CORRECTION(S) TO WATER WELL RECORD (WWC-5)

Re: Corrected water Well Location
Monitoring wells KCC
McPherson County

RUNNING TURKEY CREEK
ERRORS IN THE FINAL REPORT BY T & C MFG OPER.

3 LOCATE WELL'S LOCATION WITH AN "X" IN SECTION BOX:

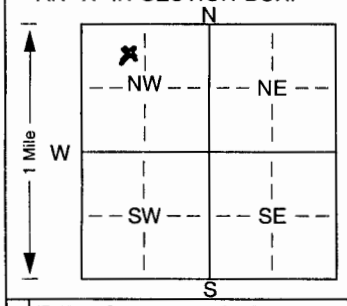
Location listed as:	**Location changed to:**
Section-Township-Range: 24-19S-2W	13-19S-2W
Fraction (¼ ¼ ¼): NE NW NW	SE SE SW SW

Comments: Latitude: 38.39161° N, Longitude: -97.49572° W

verification method: Letter and corrections from KCC, lat./long., and Galva & Canton 1:24,000 topo. maps.
